ADDENDUM NUMBER ONE (1)

PROJECT: GALVA CANAL CLASSROOM EXPANSION

OWNER: SOUTHEASTERN LOUISIANA UNIVERSITY

GGB PROJECT NO: 2607

1 WINDOW ELEVATIONS AD1-1

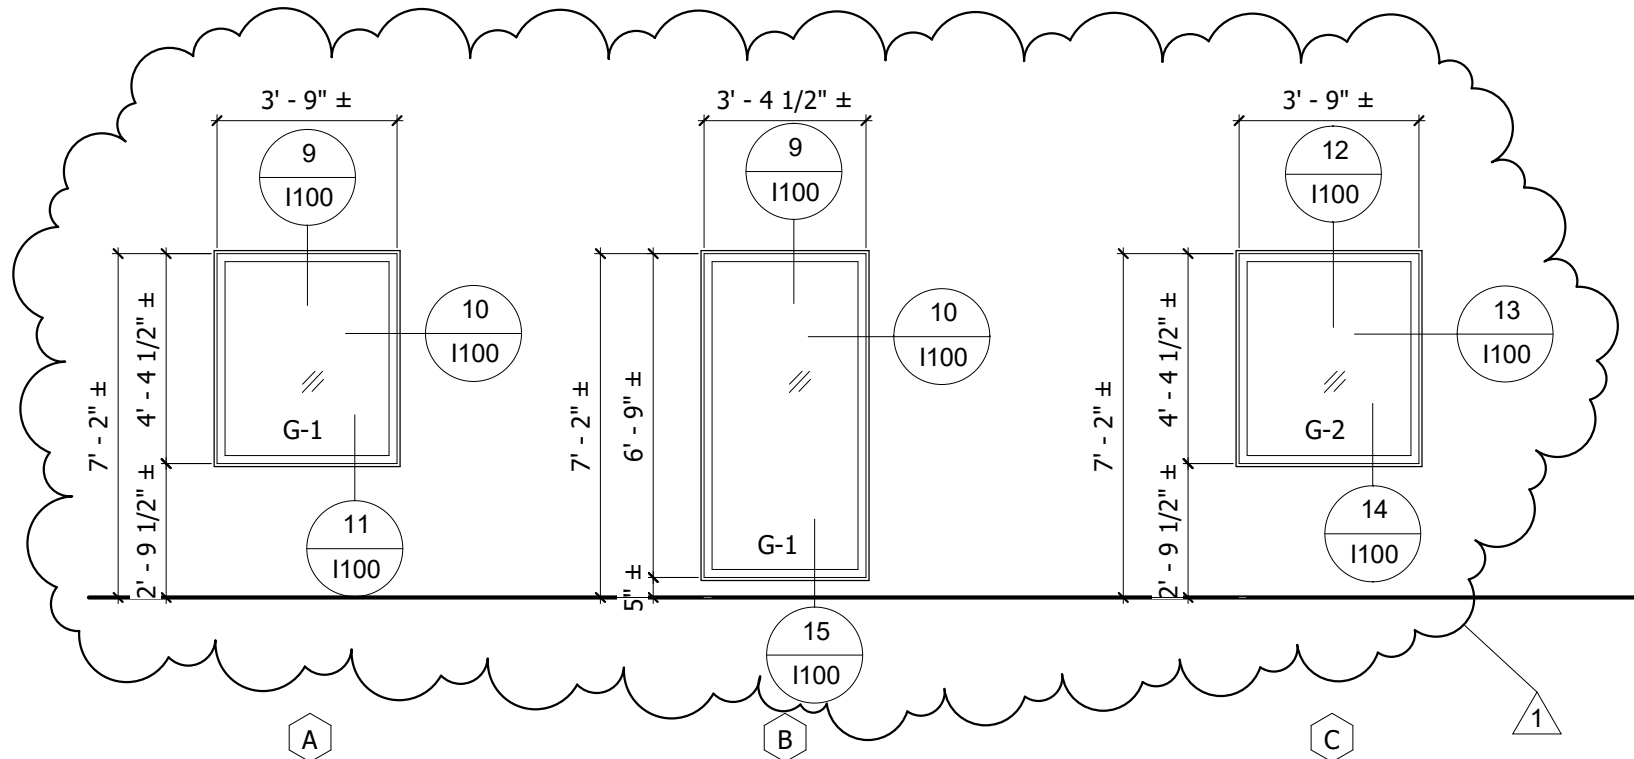
- 1.12 Refer to Sheet T101 General Information, under CODE DATA, delete the USE & OCCUPANCY CLASSIFICATION section in its entirety and replace it with the following:
*"NFPA 2015 CHAPTER 39 EXISTING BUSINESS.
IBC 2021 SECTION 304 BUSINESS GROUP B."*
- 1.13 Add attached Sketch AD1-1 WINDOW TYPES, enclosed herein as part of this addendum.
- 1.14 Add attached sketch AD1-2 POST FOUNDATION, enclosed herein as part of this addendum.
